Access Compliance Report

Public Rights-of-Way

(Curb Ramps)

Intersection ID: 46749	Main Street: NORMANS_LANDING_DR	Cross Street: HAVASU_ST	Location: NW
ADA ID: 95C28F3A7E78	Ramp Type: PerpDiag	Initial Pass/Fail: Fail	Overall Compliance: No
		Severity Score: 12.5

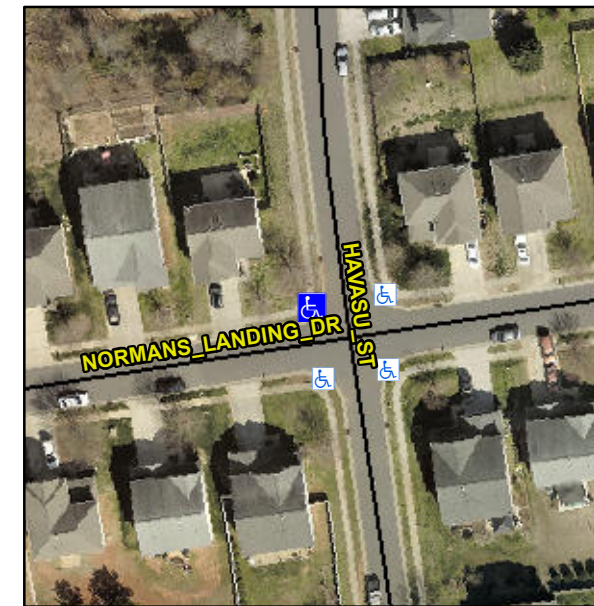
Not Found, R304.2.2

Compliance	Description	Data	Compliance	Description	Data
N/A	Ramp Length (in)	49.0	No	Ramp Slope (%)	8.9
Yes	Ramp Width (in)	48.0	Yes	Ramp XSlope (%)	0.9
N/A	Flare Type LT	N/A	N/A	Flare Type RT	N/A
N/A	Flare Slope LT (%)	N/A	N/A	Flare Slope RT (%)	N/A
N/A	Flare Traversable LT?	N/A	N/A	Flare Traversable RT?	N/A
N/A	Landing Length (in)	N/A	N/A	DWS Provided?	N/A
N/A	Landing Width (in)	N/A	N/A	DWS Contrast?	N/A
N/A	Landing Slope (%)	N/A	N/A	DWS Length (in)	N/A
N/A	Landing X Slope (%)	N/A	N/A	DWS Full Width?	N/A
N/A	Landing Curb? (Y/N)	N/A	N/A	DWS Offset (in)	N/A
N/A	Shared Landing?	N/A			
N/A	Gutter Ponding?	N/A	N/A	Gutter Slope (%)	N/A
N/A	Gutter Lip Ht (in)	N/A	N/A	Gutter X Slope (%)	N/A
N/A	Painted X Walk1?	No	N/A	Painted X Walk2?	No
	X Walk 1 Direction	To S		X Walk 2 Direction	To E
N/A	X Walk 1 Width (in)	N/A	N/A	X Walk 2 Width (in)	N/A
	X Walk 1 Slope (%)	0.3		X Walk 2 Slope (%)	2.1
	X Walk 1 X Slope (%)	2.9		X Walk 2 X Slope (%)	1.1

Remove & Replace Curb Ramp With Two New Directional Ramps or Equivalent.
